REQUEST FOR CONCURRENCE TO INITIATE SOIL STOCKPILES

As an addendum to the Area 3A/4A Integrated Remedial Design Package (IRDP), this letter is seeking your approval for the Department of Energy's (DOE) plan to initiate two temporary stockpiles for staging organically contaminated soil generated during the remediation of Area 3A for later treatment and final disposal. The two piles will be constructed within the Corrective Action Management Unit (CAMU) established in the Operable Unit 5 (OU5) Record of Decision (ROD) under the Comprehensive Environmental Response, Compensation, and Liability Act (CERCLA). These staging piles are anticipated to be needed for approximately eighteen months awaiting acceptable treatment methods to be employed. The standards established in 40 CFR 264.554, OAC 3745-56-51, and OAC 3745-56-54 were considered as applicable or relevant and appropriate requirements to be considered (ARARs/TBC) for the design and operation of these piles. A crosswalk matrix summarizing the proposed action and relevant design and operating criteria in these ARARs/TBC is enclosed (see Enclosure 1) for your reference. This crosswalk also provides information as to how the require

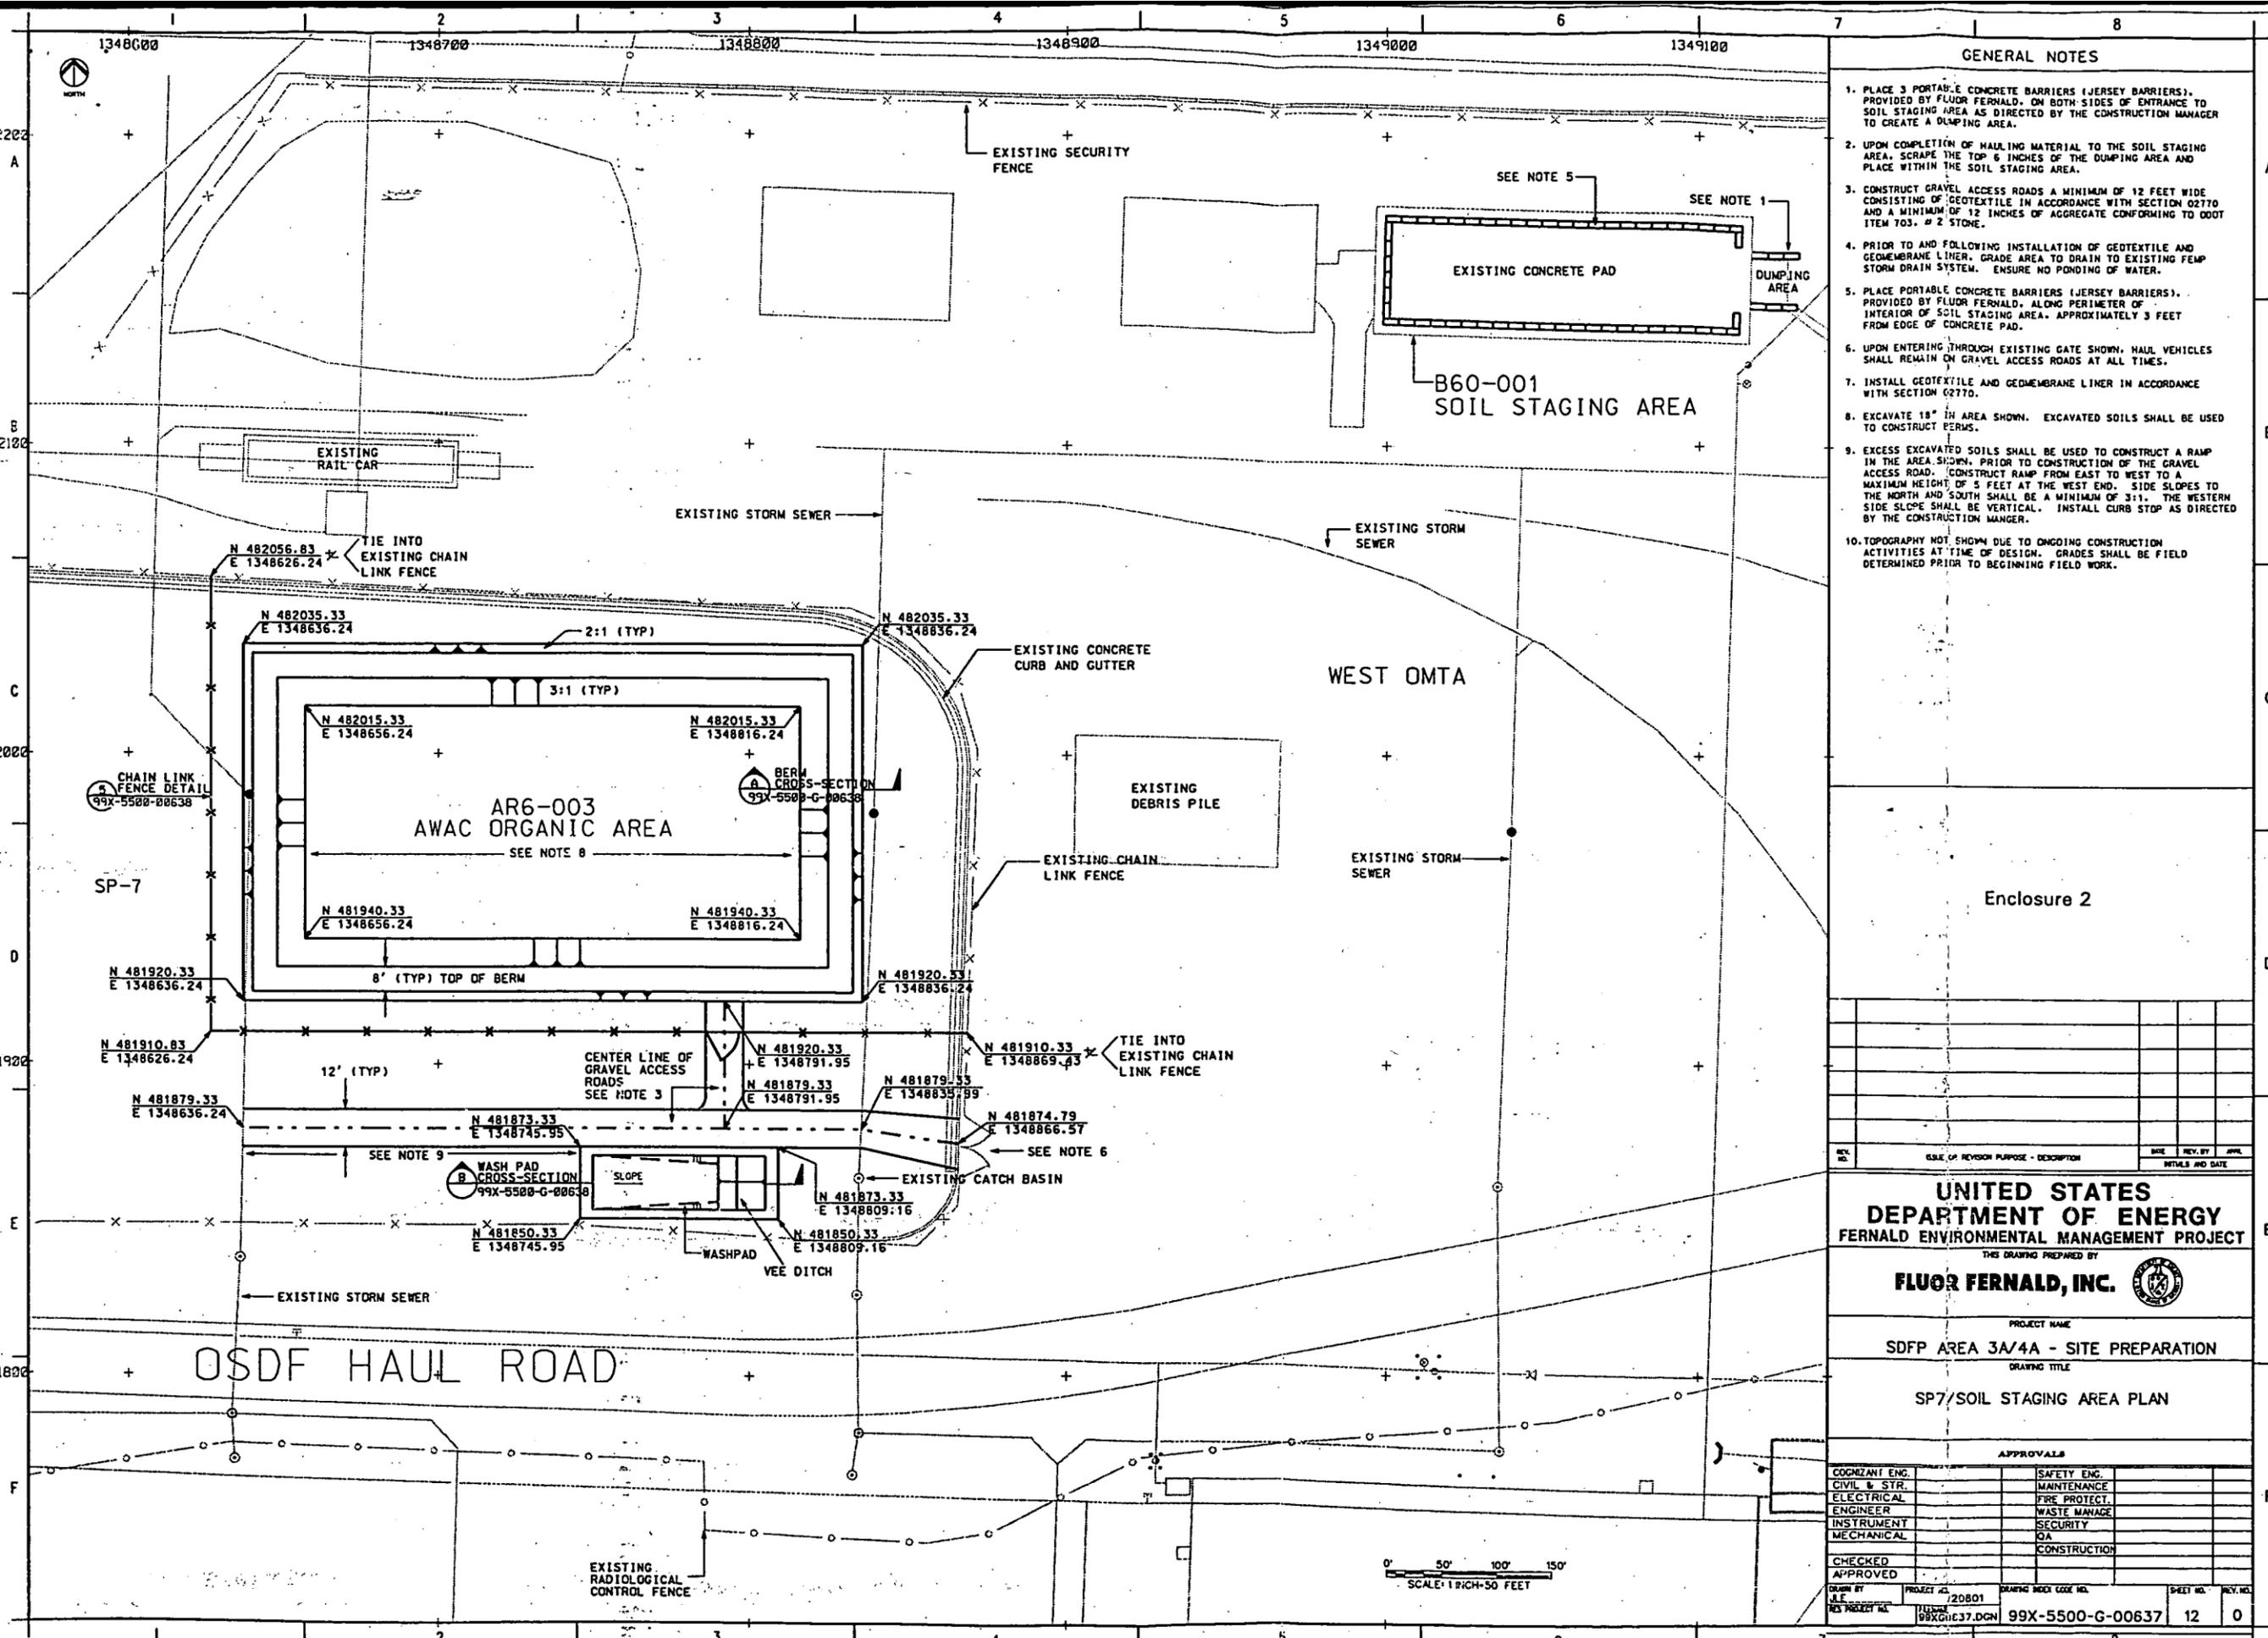
One of the stockpiles will be situated in the northeastern section of the Stock Pile 7 (SP-7) footprint located north of the former production area and will be given a new designation of Stock Pile AR6-003 (see Enclosures 2 and 3). The existing SP-7 material will be consolidated in the southwestern portion of the current footprint or removed altogether and sent to the waste pits. To construct the stockpile, the northeastern portion of SP-7 footprint will be excavated to a depth of 18 inches and a 3-foot berm will be created utilizing the excavated soil. This new surface, including the berm, will be lined with a geotextile cushioned layer and an 80mil High-Density Polyethylene (HDPE) liner, which will be anchored into the wall of the berm. About 1,700 cubic yards (yd³) of contaminated soil that is above the On-Site Disposal Facility (OSDF) Waste Acceptance Criteria (WAC) for tetrachloroethylene (PCE) and dichloroethylene (DCE) originating from Area 3A (incinerator pad) will be excavated and staged in this new area. Enclosure 4 is a table that describes the chemical characteristics of the material that will comprise the stockpile. The pile will be covered with a 60-mil or greater thickness HDPE and as well, will be anchored into the berm, but at a point lower than that of the liner as shown in Enclosures 2 and 3. By using a cover system in this manner, no precipitation is anticipated to come in contact with the waste and therefore, no noticeable leachate is expected to be generated. Correspondingly, a leachate collection and removal system is deemed to be unnecessary. All runoff above the HDPE cover from this area will be directed to the storm sewer inlet already in place. The construction period for this stockpile is anticipated to begin in November 2001 with liner construction, in December 2001 with waste placement, and the cover will be completed before the 2002 construction season, i.e. April 1, 2002.
